240 Volt Board Glacier, TMX, TMDZ, XTM, Supakool,

We have had some inquiry's regarding 240Volt boards in the above-mentioned models, there has been 2 versions used in these models and there has been a bit of confusion regarding the wiring and change over.

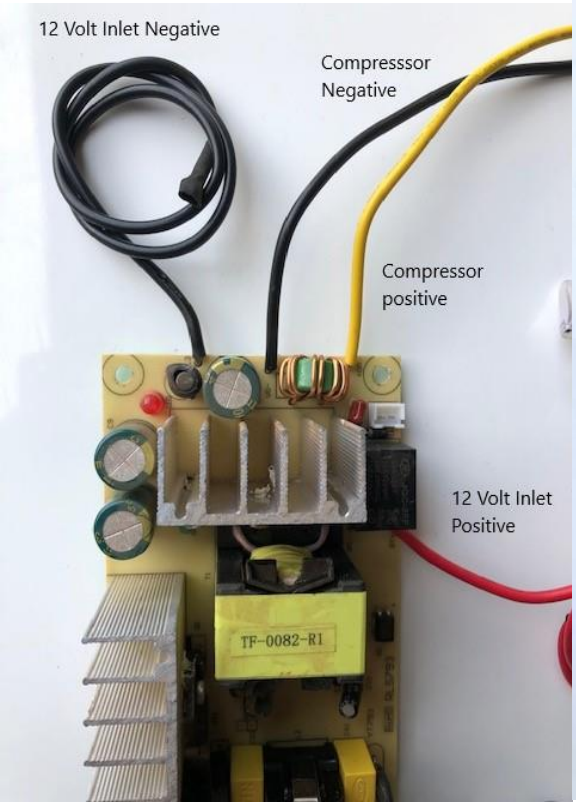
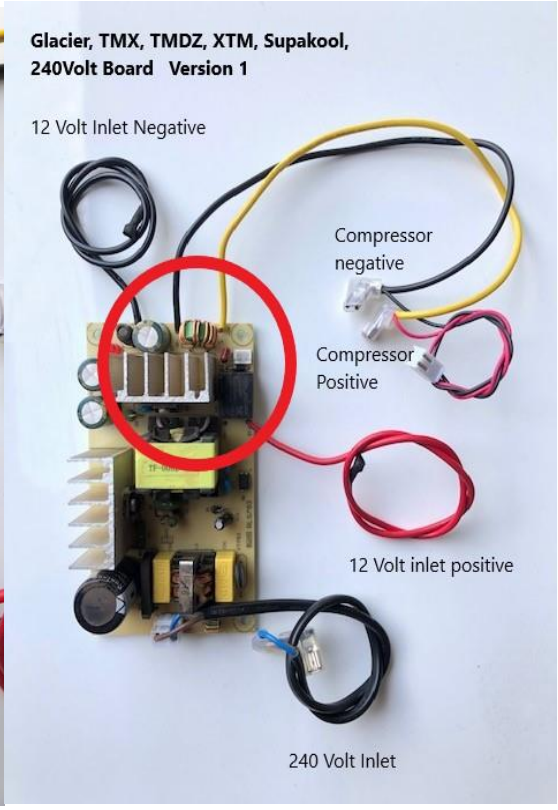
We are only carrying Version 1 boards and the retro fit from a version 2 to a version 1 is a simple one, there are only 4 wires to be re-soldered. See attached photos showing the wire placement on both boards circled in RED.

NB. When changing from a version 2 board to a version 1 board you will need the plastic cradle as well, as they are different sizes.
